813-913 WALLGROVE ROAD EASTERN CREEK

LANDSCAPE MASTERPLAN AMENDMENTS: SUPPLEMENTARY SUBMISSION
FOR GAZCORP PTY LTD

SITE IMAGE
18 MARCH 2015 - ISSUE B

AMENDED MASTERPLAN

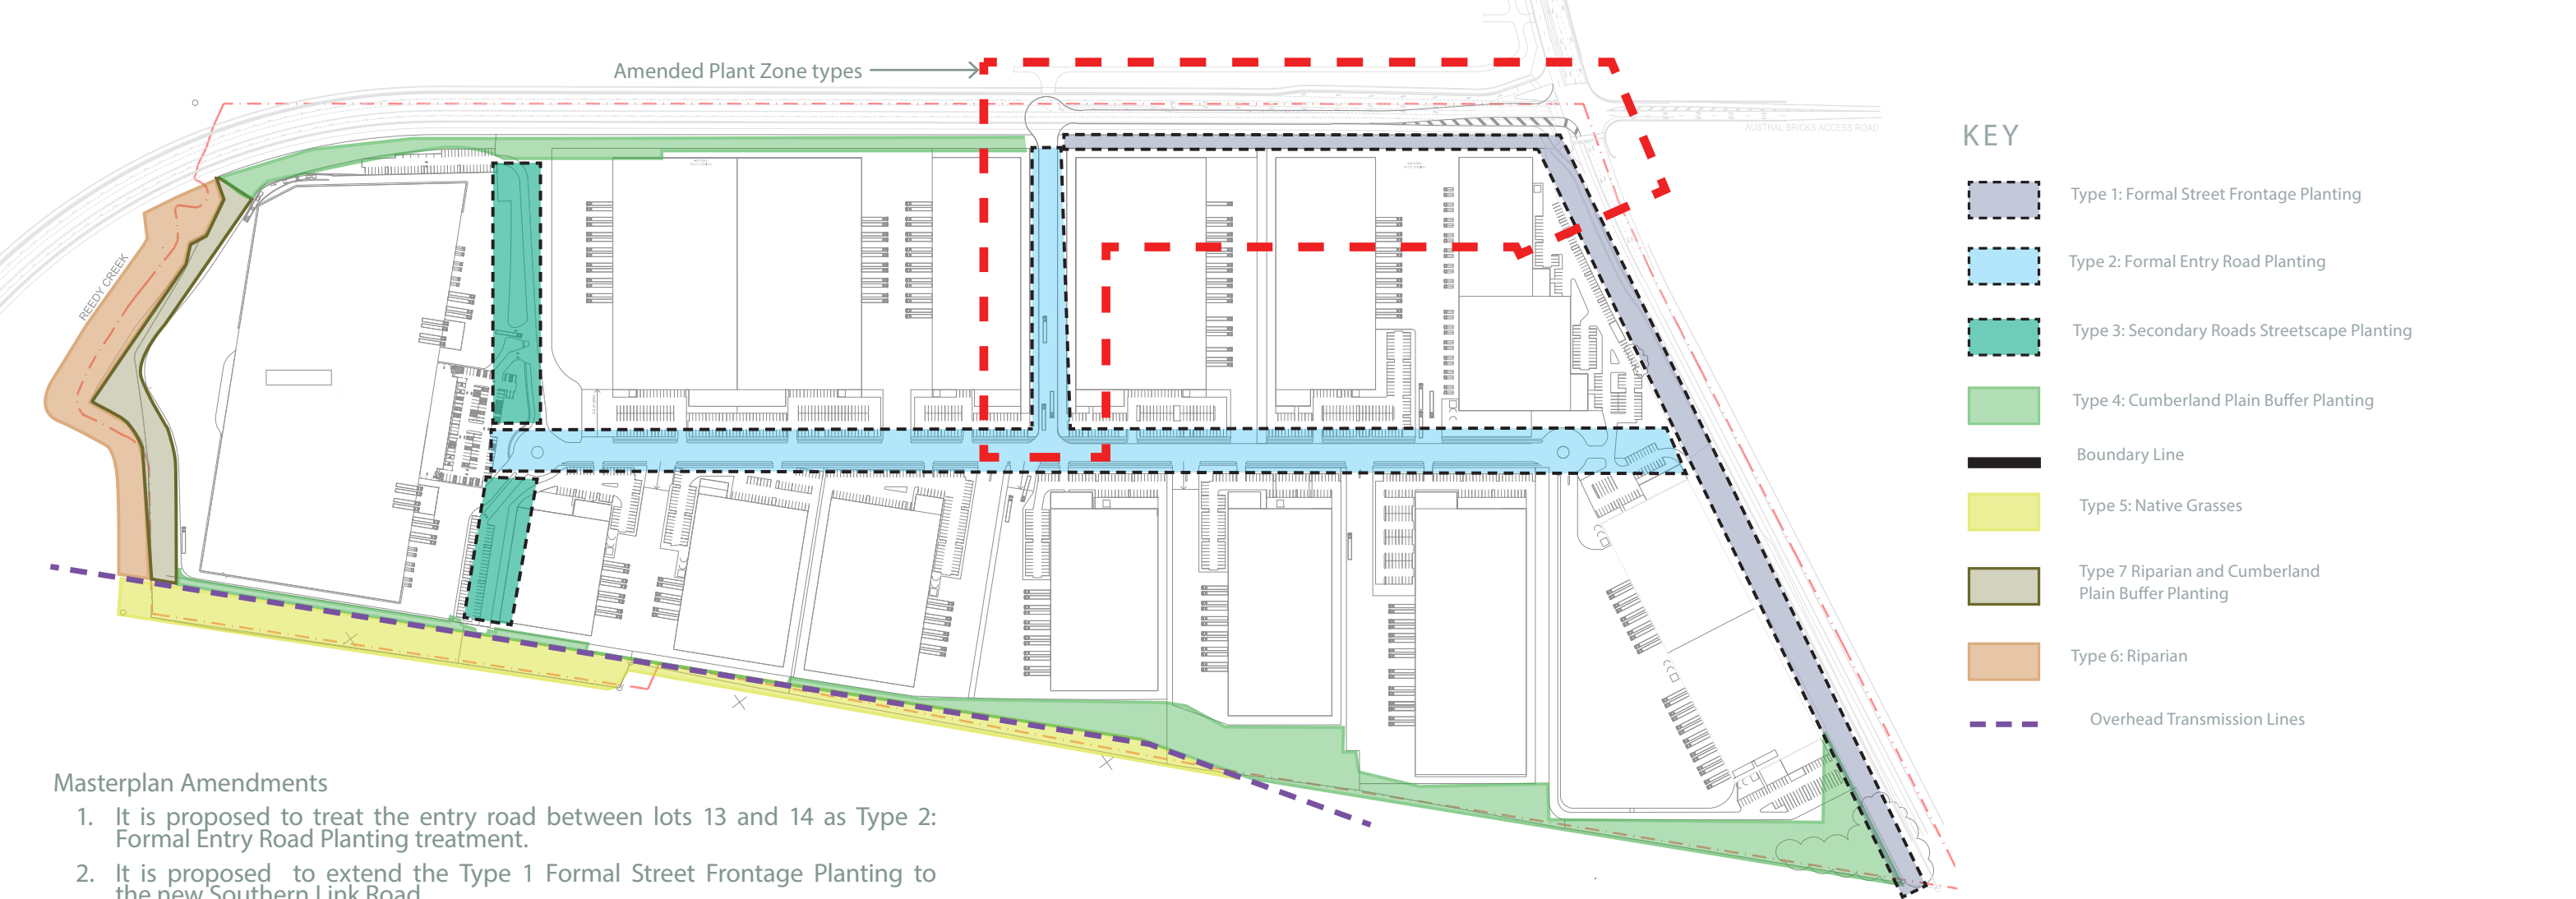
The amended masterplan (produced by MBMO Architects above) indicated a new entry arrangement between lots 13 and 14 off the Souther Link Road and amendments to the lot 3 arrangement adjacent to Wallgrove Road. This supplementary landscape design report details any associated landscape amendments to the previously submitted landscape design report.

INDICATIVE SITE ENTRY TREATMENT

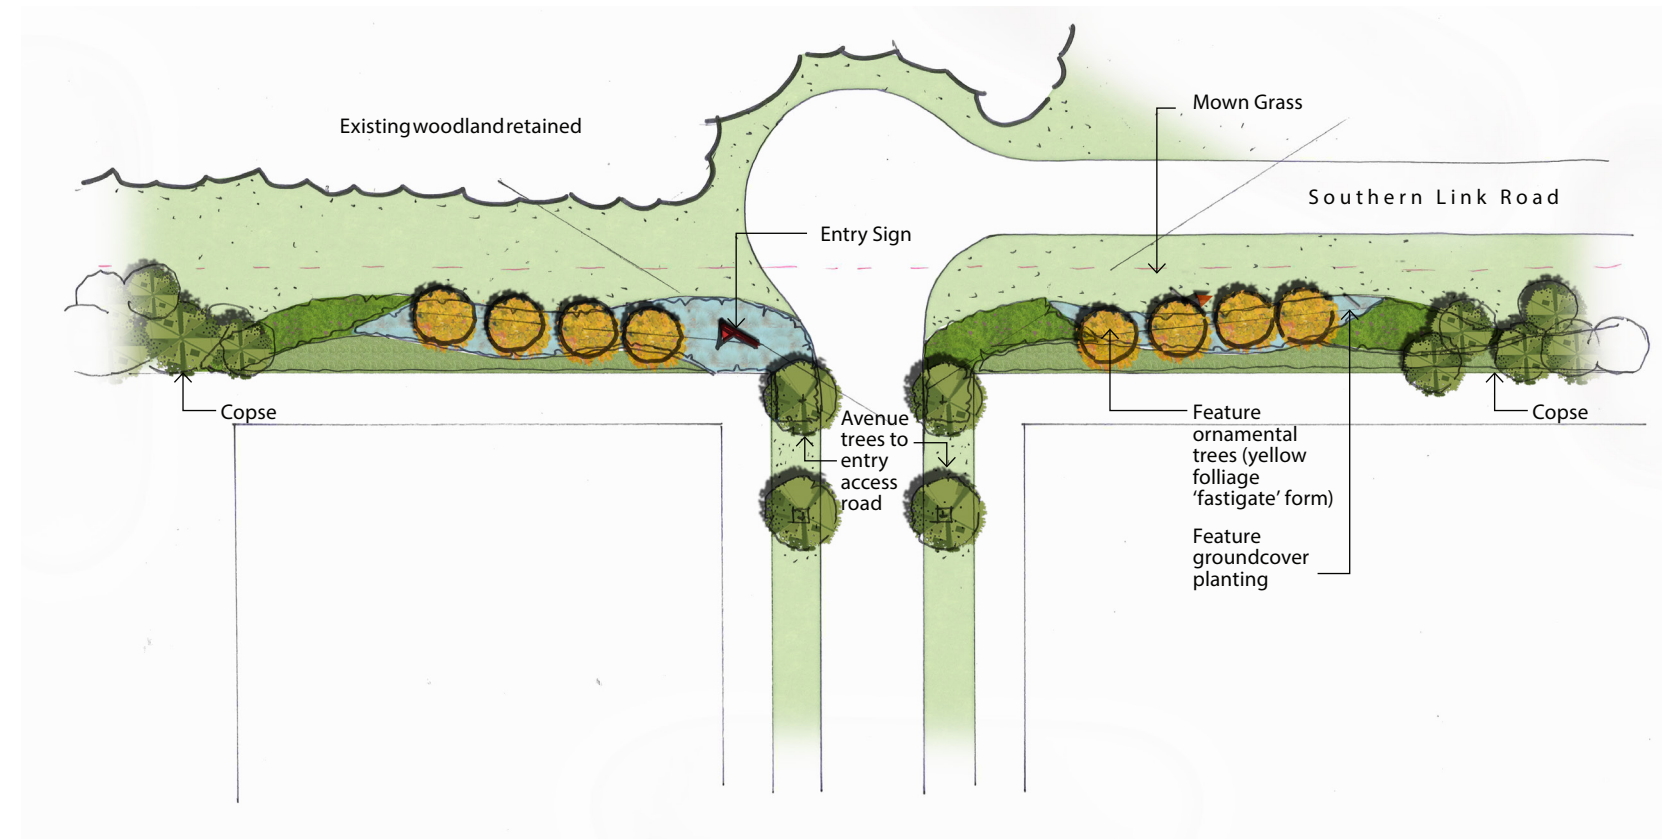
Although the location of the entry has changed, it is still proposed to create a landscape design that will accentuate the arrival to site with a formal array of ornamental trees to contrast with large canopy copse planting.

This treatment is proposed on the approach to the Southern Link Road Intersection on the Wallgrove Road verge and also either side of the Estate Entry access along the Southern Link Road verge.

As previously proposed, Liriodendron tulipifera 'fastigiatum' is the species proposed for this ornamental tree, with understory native grass plants such as Liriope "Evergreen Giant" or Anigozanthos "Kangaroo Paw" & contrasting hummock forming grasses such as Festuca glauca and Lomandra tanika.
